Access Compliance Report

Public Rights-of-Way

(Curb Ramps)

Intersection ID: 30503	Main Street: SHARON_RD	Cross Street: QUAIL_PARK_DR	Location: NW
ADA ID: 05215D566353	Ramp Type: PerpDiag	Initial Pass/Fail: Fail	Overall Compliance: No
		Severity Score: 10

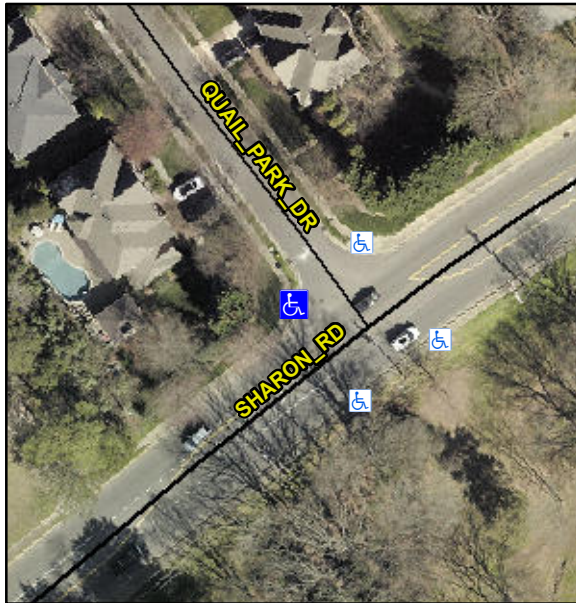
Not Found, R304.5.1, R304.5.3

Compliance	Description	Data	Compliance	Description	Data
N/A	Ramp Length (in)	92.0	Yes	Ramp Slope (%)	6.5
No	Ramp Width (in)	46.5	No	Ramp XSlope (%)	3.3
N/A	Flare Type LT	N/A	N/A	Flare Type RT	N/A
N/A	Flare Slope LT (%)	N/A	N/A	Flare Slope RT (%)	N/A
N/A	Flare Traversable LT?	N/A	N/A	Flare Traversable RT?	N/A
N/A	Landing Length (in)	N/A	N/A	DWS Provided?	N/A
N/A	Landing Width (in)	N/A	N/A	DWS Contrast?	N/A
N/A	Landing Slope (%)	N/A	N/A	DWS Length (in)	N/A
N/A	Landing X Slope (%)	N/A	N/A	DWS Full Width?	N/A
N/A	Landing Curb? (Y/N)	N/A	N/A	DWS Offset (in)	N/A
N/A	Shared Landing?	N/A			
N/A	Gutter Ponding?	N/A	N/A	Gutter Slope (%)	N/A
N/A	Gutter Lip Ht (in)	N/A	N/A	Gutter X Slope (%)	N/A
N/A	Painted X Walk1?	No	N/A	Painted X Walk2?	No
	X Walk 1 Direction	To SE		X Walk 2 Direction	To NE
N/A	X Walk 1 Width (in)	N/A	N/A	X Walk 2 Width (in)	N/A
	X Walk 1 Slope (%)	8.0		X Walk 2 Slope (%)	4.1
	X Walk 1 X Slope (%)	0.1		X Walk 2 X Slope (%)	2.3

Remove & Replace Curb Ramp With Two New Directional Ramps or Equivalent.
